January 20, 2022  
File No. 05.00043654.60

Re: Site Remediation File No. SR-26-0934A/Formerly RIDEM Case No. 95-022  
Former Tidewater Facility  
200 Taft Street  
Pawtucket, Rhode Island

### CRMC ASSENT MODIFICATION

**ALTERNATIVE REVEMENT LAYOUT PLAN**

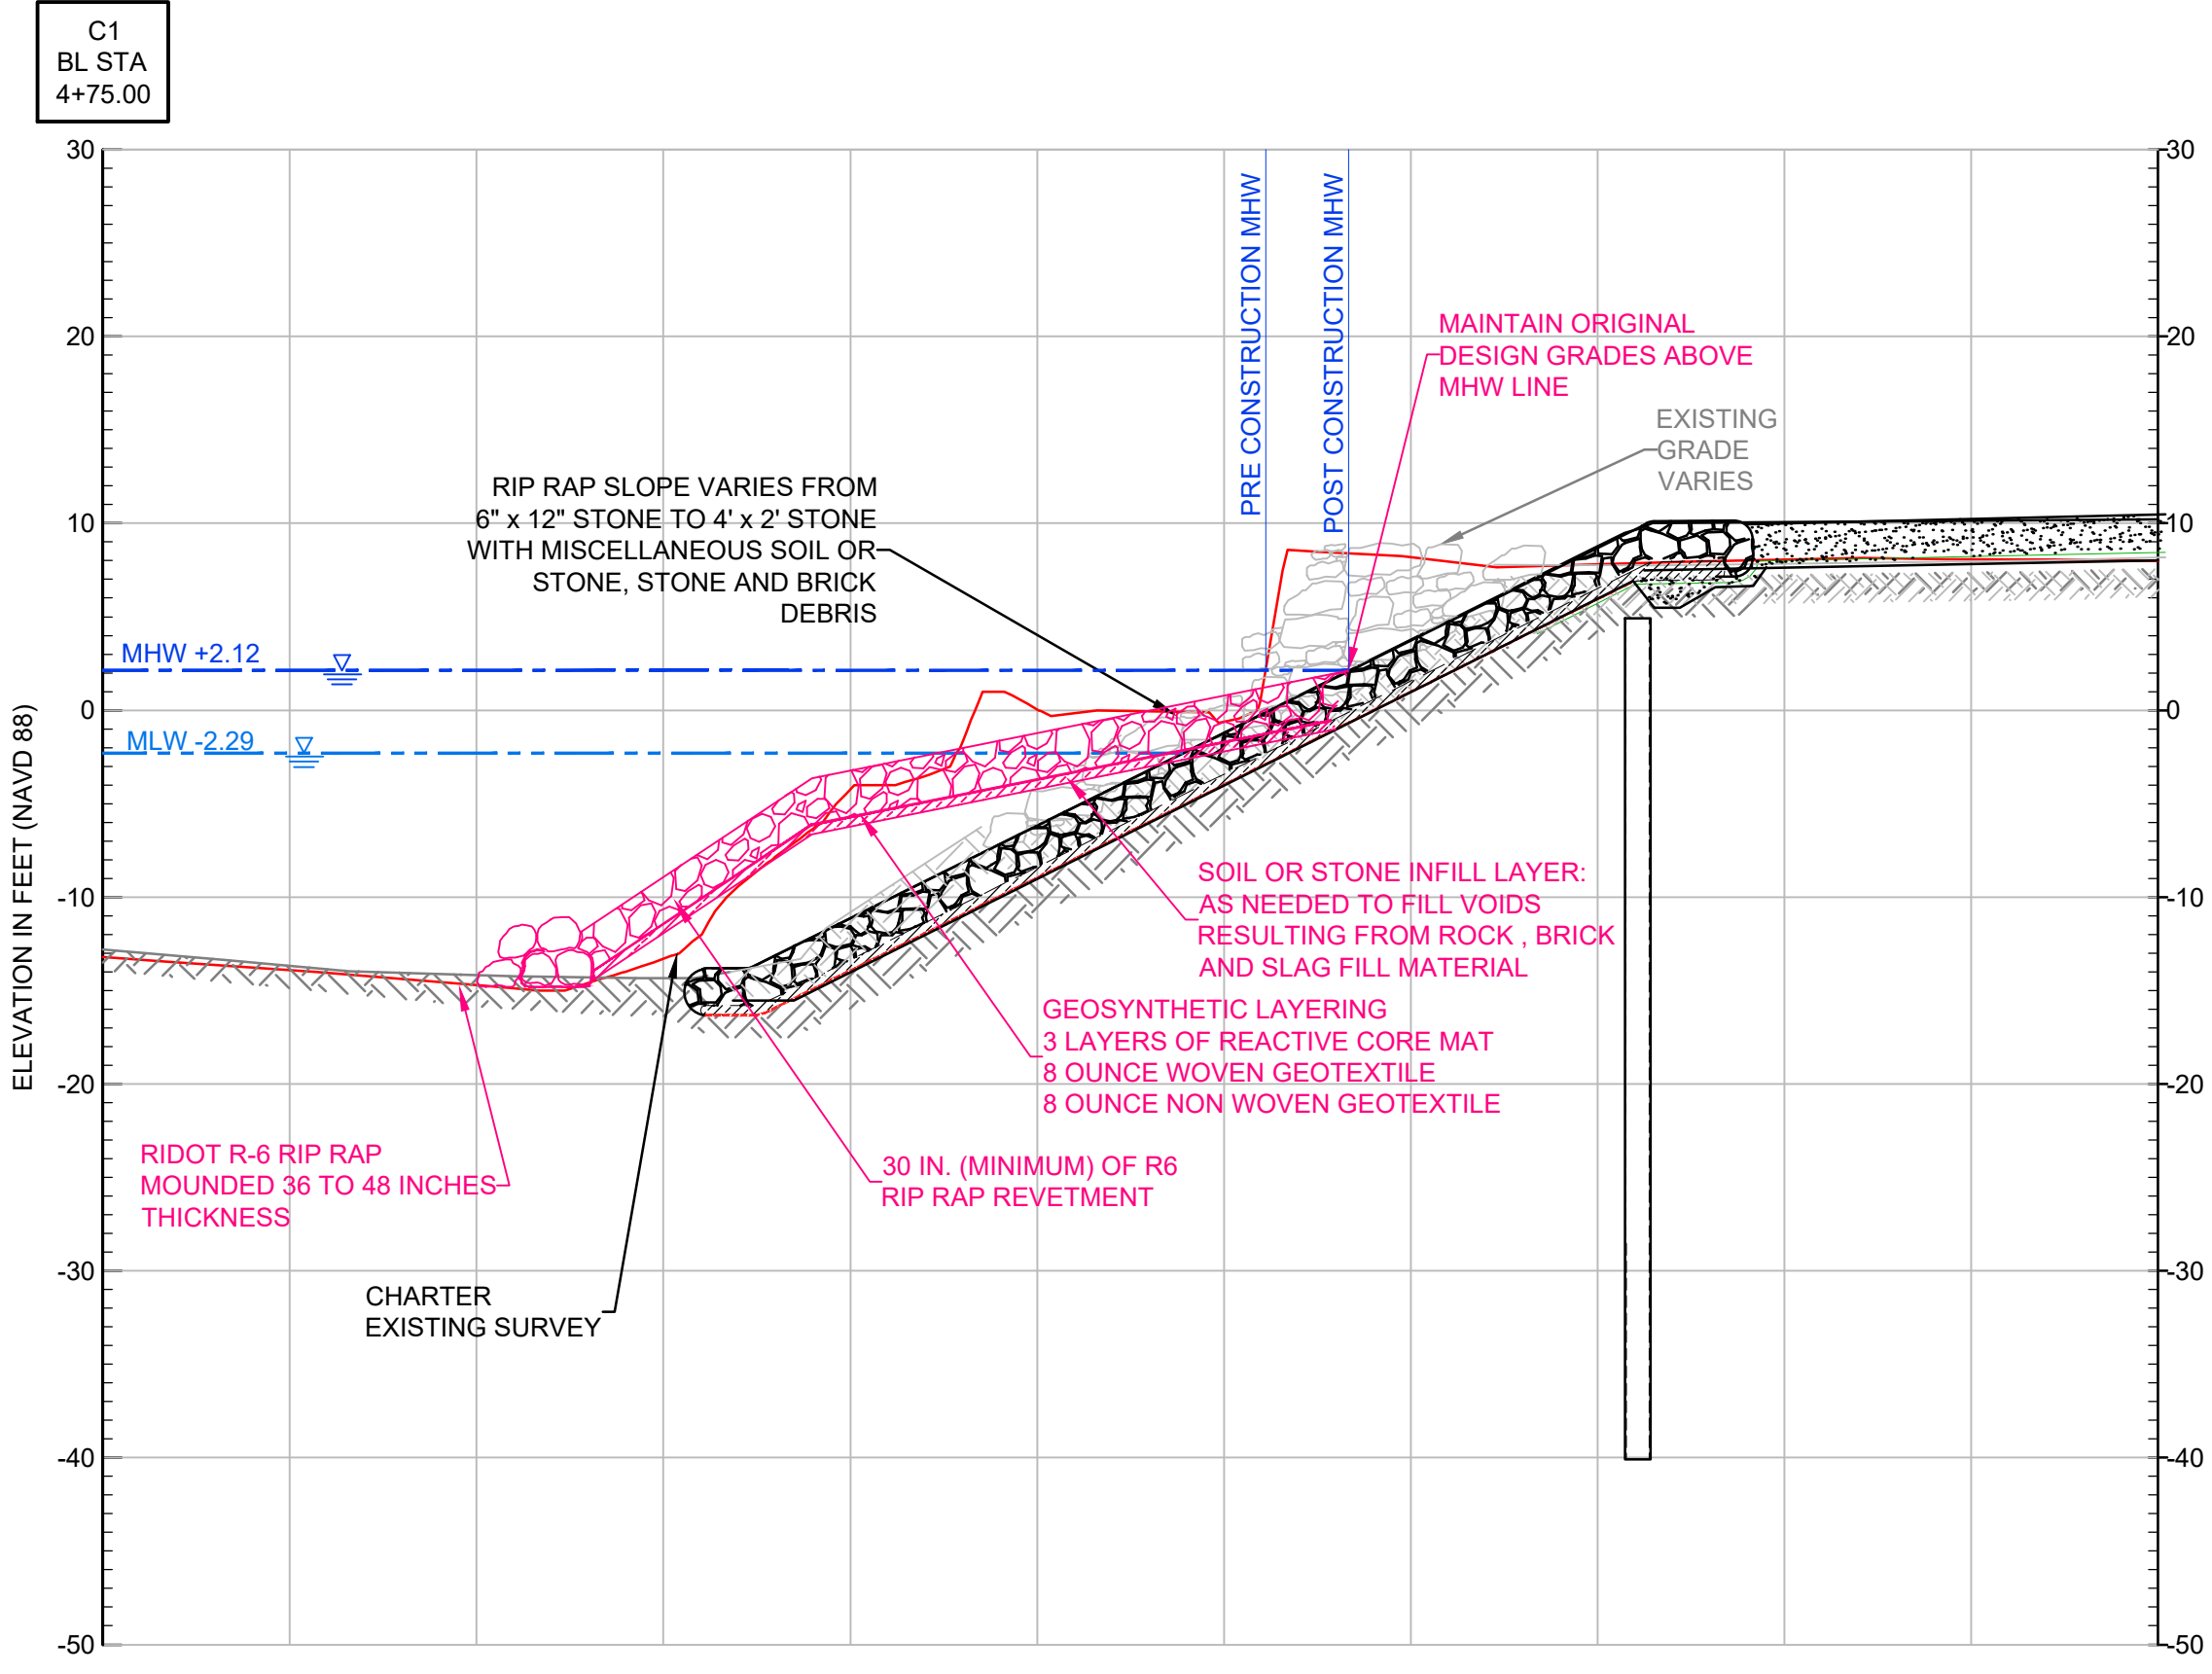
**RE: CRMC File Number:** 2019-08-014 Modification of Assent, to include modifying revetment design in the Northern portion of the Site between Stations 4+00 and 5+95 (approximately 195 feet along the shoreline) to minimize the disturbance of coal tar impacted soil.

2. The approved site plans shall be those titled "Former Tidewater Facility, Pawtucket, Rhode Island, Contract Document Phase 4 and 4, Alternative Revetment Layout Plan...", sheets 1 and 2 (Drawing S-62A and S-65A) dated January 2022, by GZA Inc.. Except as stipulated or modified herein, all details and specifications thereon shall be strictly adhered to. Any and all changes require written approval from this office.

Due to the finding of additional contaminated soils within the project footprint, the original permit is hereby modified to increase the amount of permanent rip rap fill discharge by an additional 1,800 square-feet(sf) from 12,900sf to 14,700sf seaward of the HTL. The discharge of additional rip rap fill will cover an expanded contamination cap for the newly identified area of contaminants. This will prevent the discharge/erosion of the contaminated soils into the Seekonk River. Furthermore, the area of originally permitted dredging will be reduced by 1,800sf from the originally permitted 18,400sf to 16,600sf.
